PRODUCT CHANGE NOTIFICATION (PCN)

A-MCSP-80070/R MODULAR CABLE

CHANGE NOTIFICATION: PCN 20220425_A-MCSP-80070/R

DESCRIPTION OF CHANGES: CHANGE OF DATA SHEET
CHANGE OF DATA SHEET
New Draw.-No. ASS_7425_CArev07

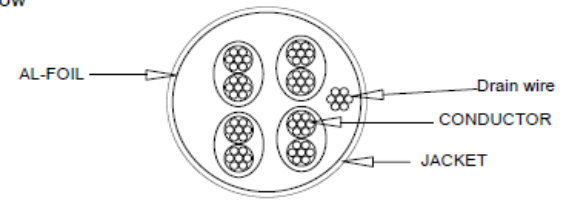
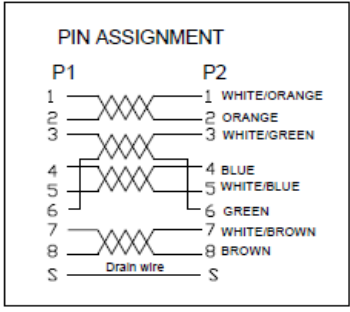
A-MCSP-80070/R	OLD VERSION	A-MCSP-80070/R	NEW VERSION																																																	
<p>Appearance</p>		<p>Appearance</p>																																																		
<p>BOM</p> <table border="1"> <thead> <tr> <th>NO</th> <th>PART NO</th> <th>DESCRIPTION</th> <th>QTY</th> <th>UNIT</th> </tr> </thead> <tbody> <tr> <td>3</td> <td>mold</td> <td>PVC,50P</td> <td>9.0</td> <td>G</td> </tr> <tr> <td>2</td> <td>plug</td> <td>8P8C plating gold 3U* with metal shield</td> <td>2</td> <td>PCS</td> </tr> <tr> <td>⑤ 1</td> <td>cable</td> <td>FTP (26AWG*1P)*4+D+A+PVC, OD:5.2±0.2mm CAT5E</td> <td>2.0</td> <td>M</td> </tr> </tbody> </table>		NO	PART NO	DESCRIPTION	QTY	UNIT	3	mold	PVC,50P	9.0	G	2	plug	8P8C plating gold 3U* with metal shield	2	PCS	⑤ 1	cable	FTP (26AWG*1P)*4+D+A+PVC, OD:5.2±0.2mm CAT5E	2.0	M	<p>BOM</p> <table border="1"> <thead> <tr> <th>NO</th> <th>PART NO</th> <th>DESCRIPTION</th> <th>QTY</th> <th>UNIT</th> </tr> </thead> <tbody> <tr> <td>⑦</td> <td>⚠</td> <td>AL-Foil</td> <td>Double-sided conductive aluminum foil</td> <td>2</td> <td>PCS</td> </tr> <tr> <td>⑦</td> <td>⚠</td> <td>mold</td> <td>PVC,65P</td> <td>AR</td> <td>G</td> </tr> <tr> <td></td> <td>⚠</td> <td>plug</td> <td>8P8C plating gold 3U* with metal shield</td> <td>2</td> <td>PCS</td> </tr> <tr> <td>⑦⑤</td> <td>⚠</td> <td>cable</td> <td>CAT5E F/UTP (26AWG*1P)*4+D+A+PVC, OD:5.2±0.2mm</td> <td>AR</td> <td>M</td> </tr> </tbody> </table>		NO	PART NO	DESCRIPTION	QTY	UNIT	⑦	⚠	AL-Foil	Double-sided conductive aluminum foil	2	PCS	⑦	⚠	mold	PVC,65P	AR	G		⚠	plug	8P8C plating gold 3U* with metal shield	2	PCS	⑦⑤	⚠	cable	CAT5E F/UTP (26AWG*1P)*4+D+A+PVC, OD:5.2±0.2mm	AR	M

NO	PART NO	DESCRIPTION	QTY	UNIT																																																
3	mold	PVC,50P	9.0	G																																																
2	plug	8P8C plating gold 3U* with metal shield	2	PCS																																																
⑤ 1	cable	FTP (26AWG*1P)*4+D+A+PVC, OD:5.2±0.2mm CAT5E	2.0	M																																																
NO	PART NO	DESCRIPTION	QTY	UNIT																																																
⑦	⚠	AL-Foil	Double-sided conductive aluminum foil	2	PCS																																															
⑦	⚠	mold	PVC,65P	AR	G																																															
	⚠	plug	8P8C plating gold 3U* with metal shield	2	PCS																																															
⑦⑤	⚠	cable	CAT5E F/UTP (26AWG*1P)*4+D+A+PVC, OD:5.2±0.2mm	AR	M																																															
<p>FOR DETAIL, PLEASE TAKE ATTACHED NEW DRAWING: FOR REFERENCE</p>

NO	PART NO	DESCRIPTION	QTY	UNIT
⑦	④	AL-Foil Double-sided conductive aluminum foil	2	PCS
⑦	④	mold PVC,65P	AR	G
⑦	④	plug 8P8C plating gold 3U* with metal shield	2	PCS
⑦⑤	④	cable CAT5E F/UTP (26AWG*1P)*4+D+A+PVC, OD:5.2±0.2mm	AR	M

Scale	FREE	⑦	Change the plant	12.04.2022	Luca	Date	Name	Customer-No.
TOLERANCE		⑥	Clarify the tolerance	23.08.2018	Segal	26.06.2015	Joanna	ASSMANN WSW-No. A-MCSP-80XXX/X
X.	±X	⑤	Add "CAT5E"	20.10.2017	Stephon	12.04.2022	Luca	
X.X	±X	④	Add length for 20M and 30M	20.09.2017	Fred			
X.XX	±X	③	remove mark on the mould	29.06.2016	Joanna			
DIM	TOL	②	Add length for 300mm	18.05.2015	Joanna			Drawing-No.
ANGLE	±X°							ASS 7425 CA
Angle	TOL	Id.	Modification	Date	Name			rev07
								Sheet
